HISTORIC AND DESIGN REVIEW COMMISSION

HDRC CASE NO: 2019-297
ADDRESS: 3020 BROADWAY, 108 & 110 IRA
LEGAL DESCRIPTION: NCB 3866 BLK 12 LOT NW 100 FT OF 5&6
ZONING: C-2, RIO-1
CITY COUNCIL DIST.: 2
APPLICANT: Brandon Moffett
OWNER: Skyler Cozby, BACI Partners, LTD
TYPE OF WORK: Construction of an addition, parking lot modifications
APPLICATION RECEIVED: May 15, 2019
60-DAY REVIEW: July 19, 2019
CASE MANAGER: Edward Hall

The applicant is requesting a Certificate of Appropriateness for approval to construct an addition to the existing building and expand the existing parking lot to the east to the vacant lot at 108 and 110 Ira.

SP SCALE : 1" = 15'
SITE PLAN

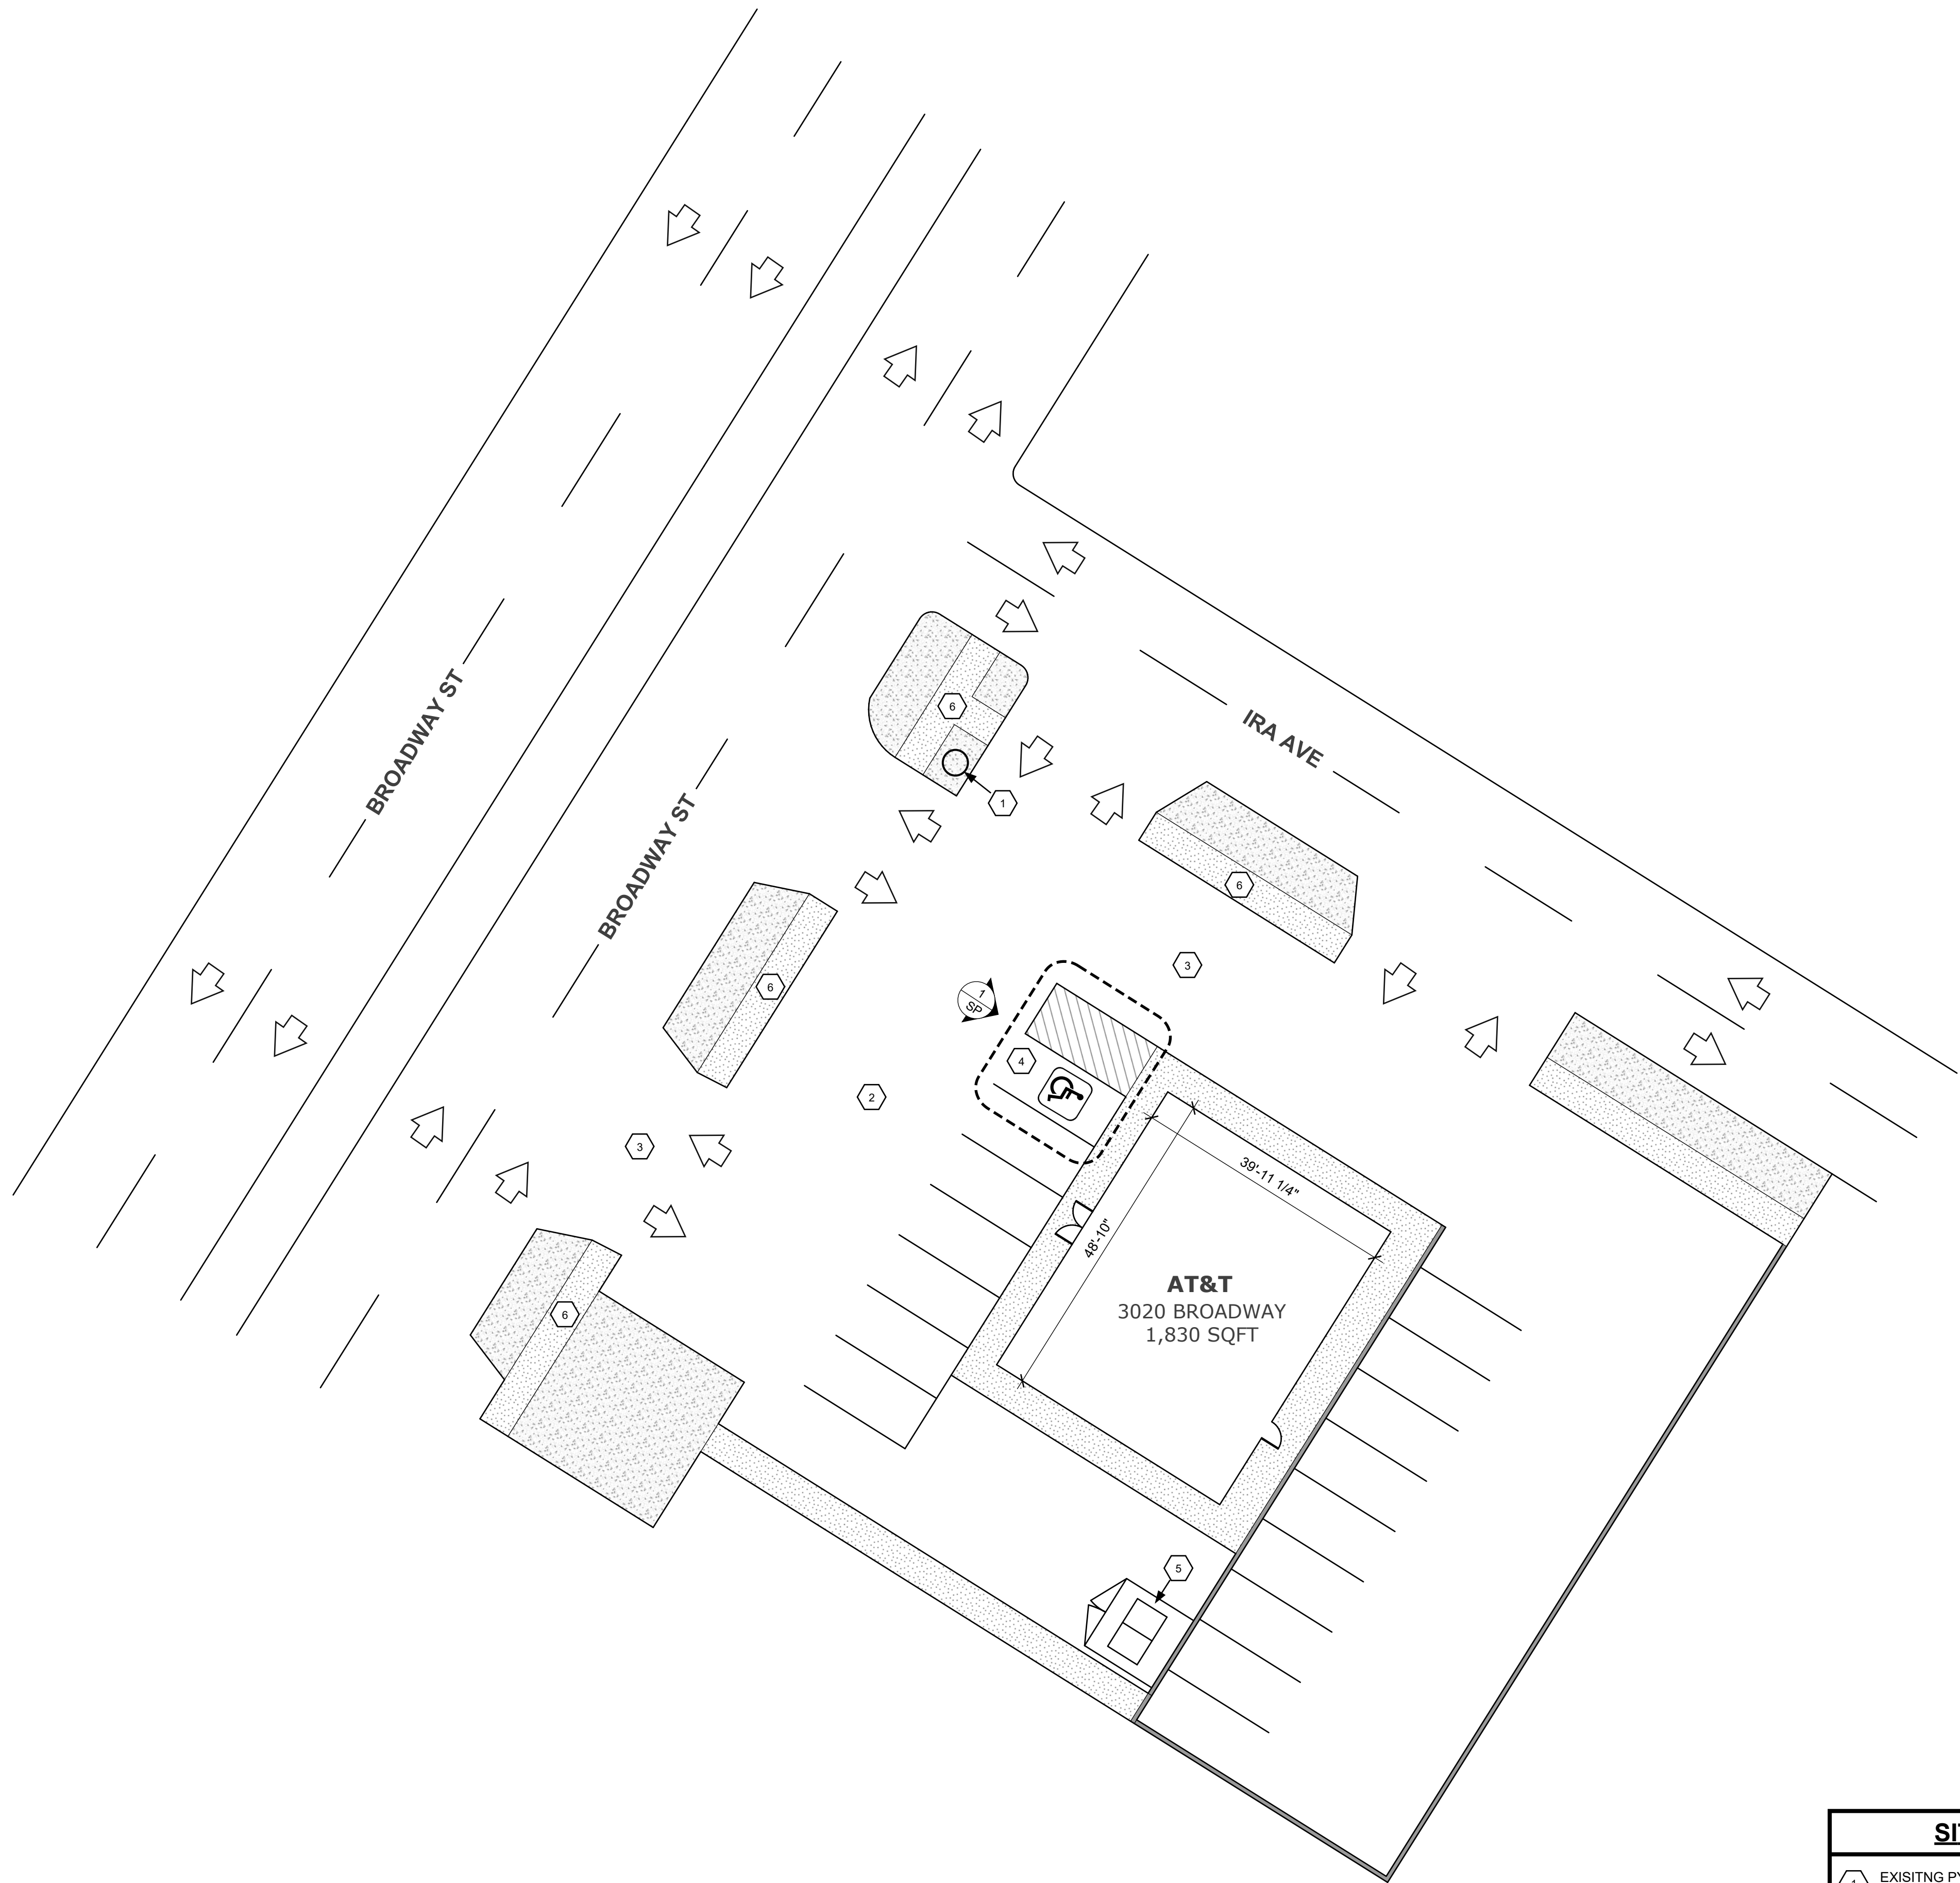
- c. PEDESTRIAN CIRCULATION – Per the UDC Section 35-672(a) in regards to pedestrian circulation, an applicant shall provide pedestrian access among properties to integrate neighborhoods. The applicant has proposed to provide pedestrian circulation adjacent to the public right of way on both Broadway and Ira, as it currently exists.

- e. SITE DESIGN – According to the UDC Section 35-673, buildings should be sited to help define active spaces for area users, provide pedestrian connections between sites, help animate the street scene and define street edges. Primary entrances should be oriented toward the street and shall be distinguishable by an architectural feature. While the applicant has not proposed a new structure, the applicant has proposed to modify the existing structure to include a new storefront system which addresses Broadway. Staff finds this to be appropriate and consistent with the Guidelines.

- g. LANDSCAPING – The UDC Section 35-673(3) provides information regarding landscape design. At this time, the applicant has not provided a detailed landscaping plan. Staff finds that the applicant should make every attempt to install landscaping elements to provide a buffer between on-site automobile parking and pedestrian traffic on sidewalks at the public right of way.

- i. That the two curb cuts immediately adjacent to the intersection of Broadway and Ira be eliminated based on finding d.
- ii. That the applicant submit a detailed landscaping plan to staff for review and approval that includes landscaping elements in each of the existing landscape islands and buffers found on site as well as automobile screening for the lot at 108/110 Ira, as noted in findings f and g.
- iii. That the applicant submit a detailed signage package for review and approval by the Commission that does not feature more than three signs that total fifty (50) square feet, and that the existing pole sign is removed as noted in finding k.
- iv. That the applicant screen and buffer all mechanical equipment from view at the public right of way as noted in finding h.
